**REMOVAL ACTION
FOR PICKLING AND PLATE YARD (IR-9)
VOLUME I - WORK PLAN
NAVAL STATION, TREASURE ISLAND
HUNTERS POINT ANNEX
SAN FRANCISCO, CALIFORNIA**

**Addendum to Draft Final
Removal Action Work Plan
Pickling and Plate Yard
Response to EPA and DHS Comments
Dated June 10 and 11, 1991
Contract No. N62474-86-D-0996
DO 045**

**ADDENDUM TO DRAFT FINAL
REMOVAL ACTION WORK PLAN FOR THE
PICKLING AND PLATE YARD
HUNTERS POINT ANNEX**

**RESPONSE AND ERRATA SHEETS IN RESPONSE TO DHS COMMENTS
DATED JUNE 10, 1991**

GENERAL DEMOLITION PLAN

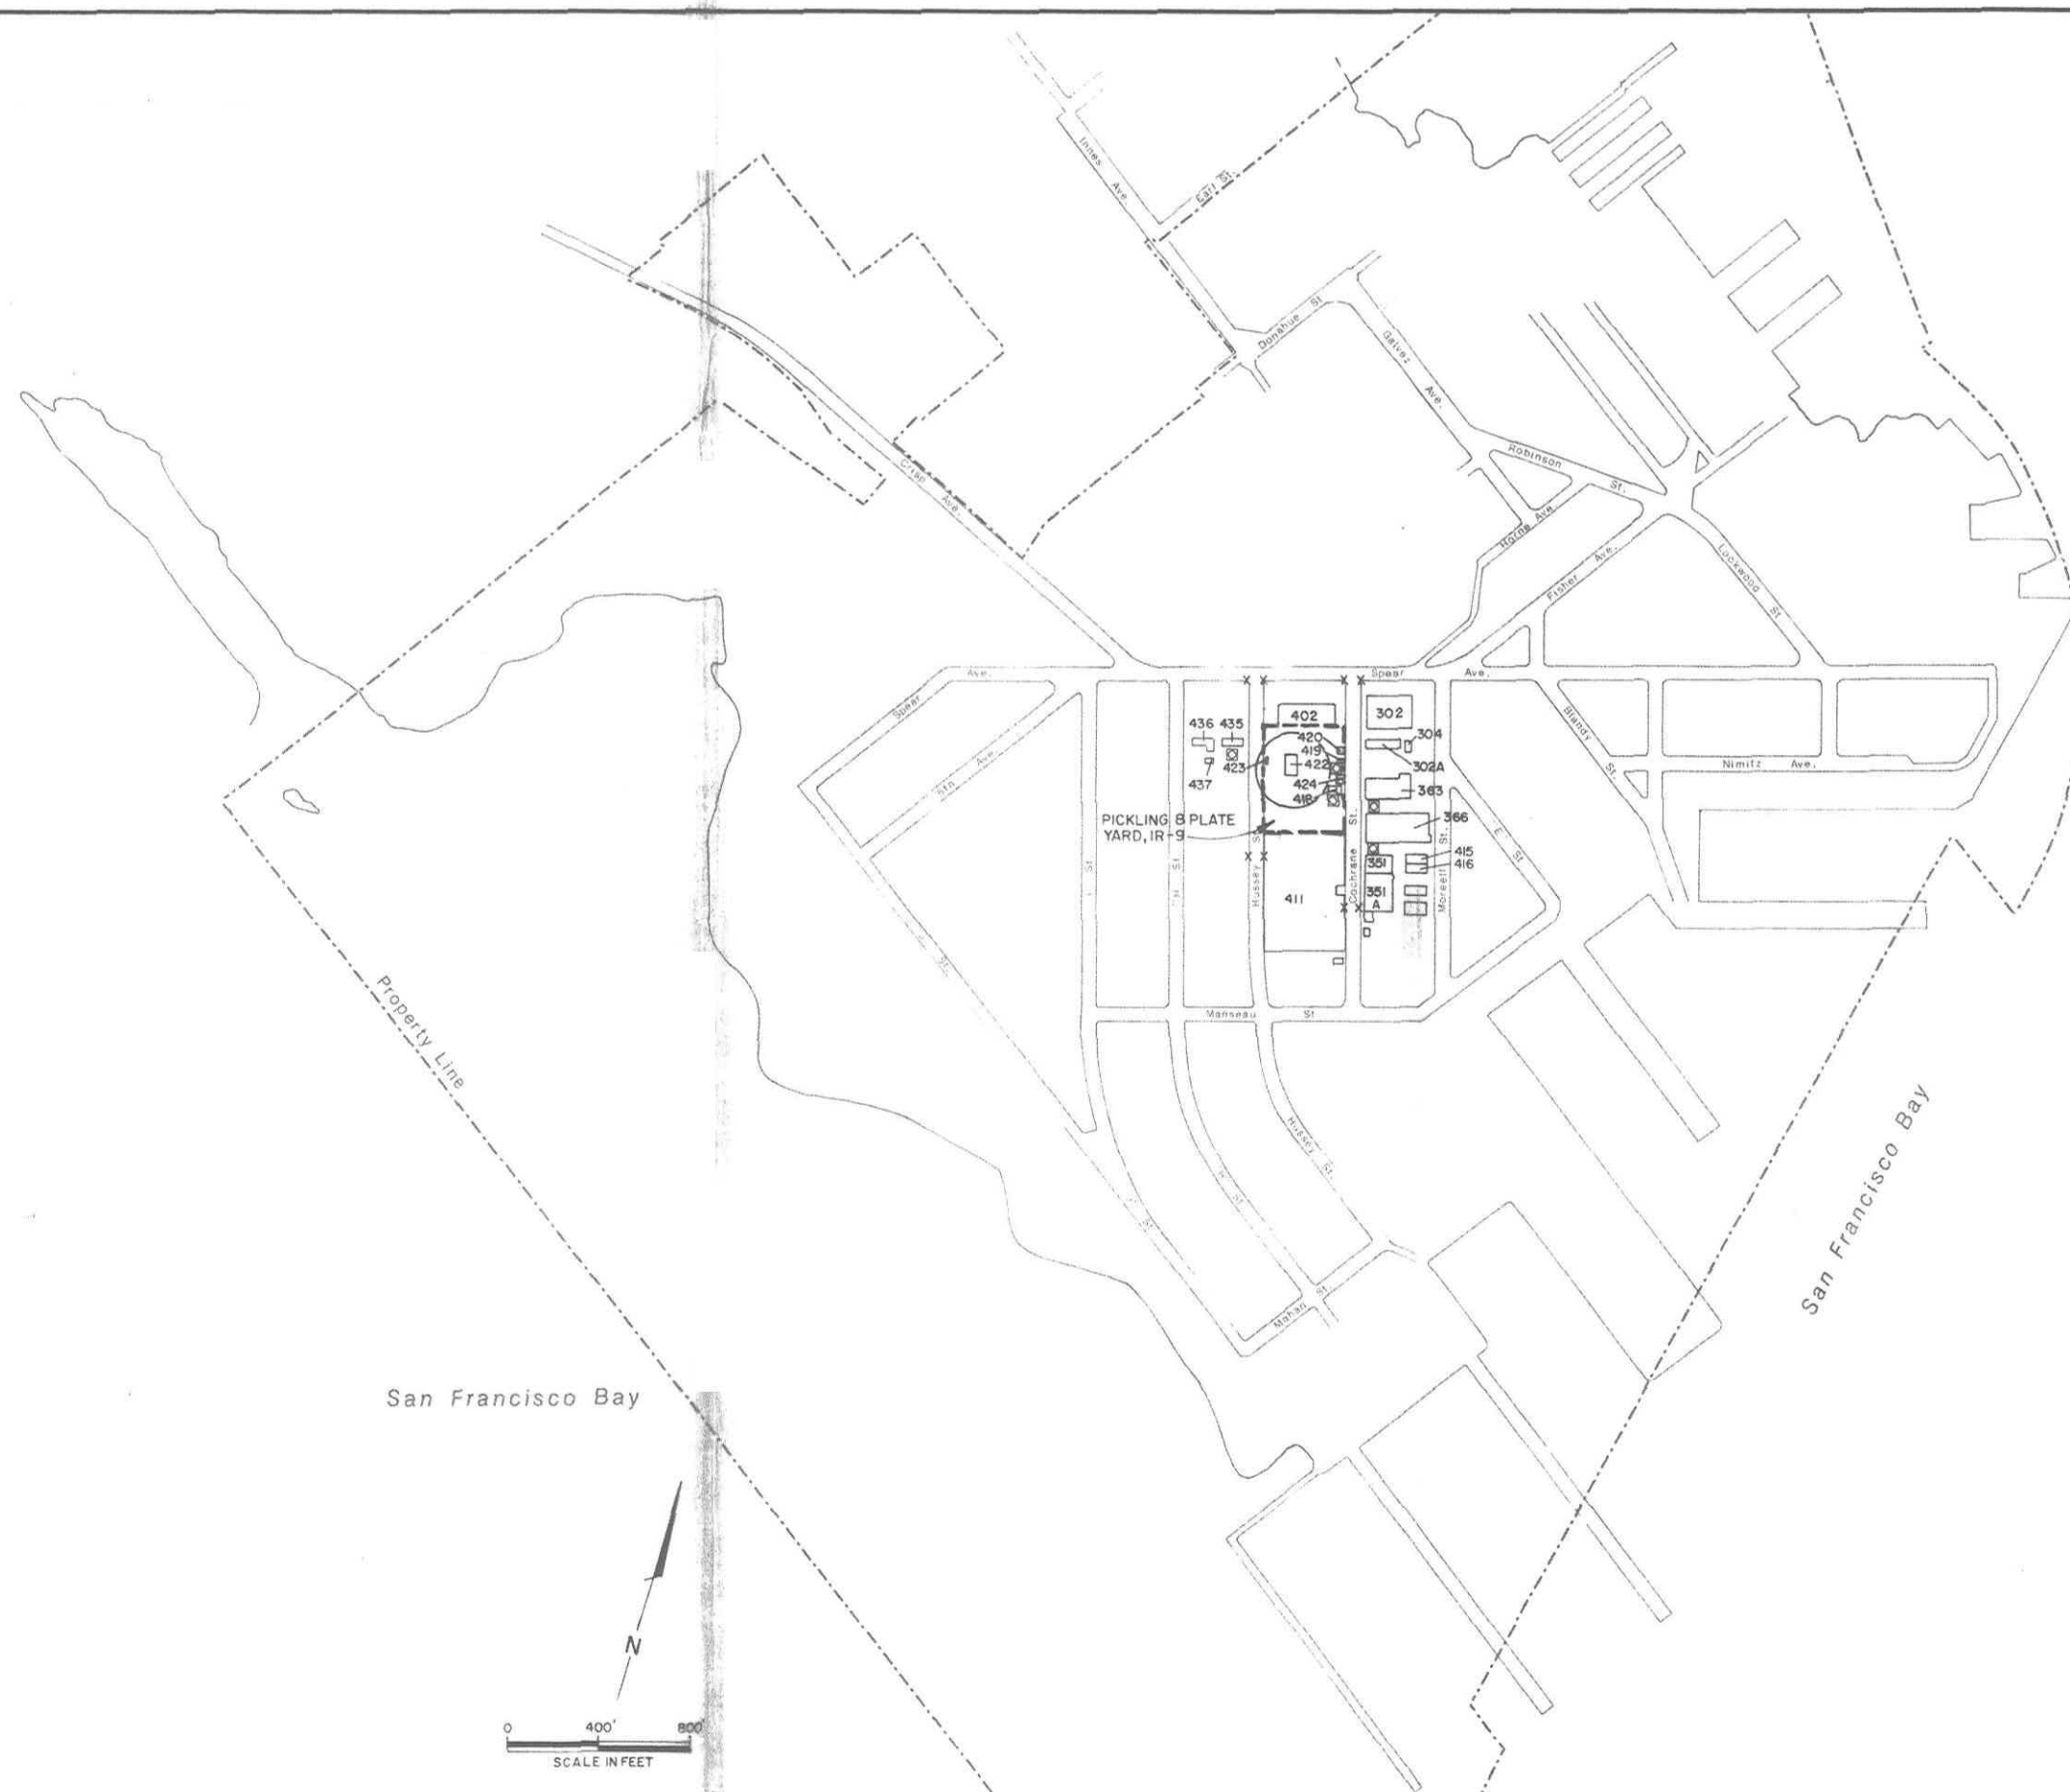
Comment 9: Page 24, second and third paragraphs. Plate 2 appears to contradict the second paragraph, in that the "transition zone" and the support zone appear to be within the exclusion zone. It also appears from Plate 3 that the decon area is well within the boundaries of the area of unacceptable health risks described in bullet #4. Please clarify this.

Comment 10: Page 26, second paragraph. Again, this description of the CRZ is contradicted by the drawing on Plate 2. Although the drawings are subject to change, it is confusing to have this apparent contradiction. Plate 2 should be redrawn to show the CRZ and support zone outside the exclusion zone.

Response: Plate 2 has been revised to show the correct locations of the support zone, the exclusion zone and the decontamination area.

Response: These corrections have been made on Plate 2.
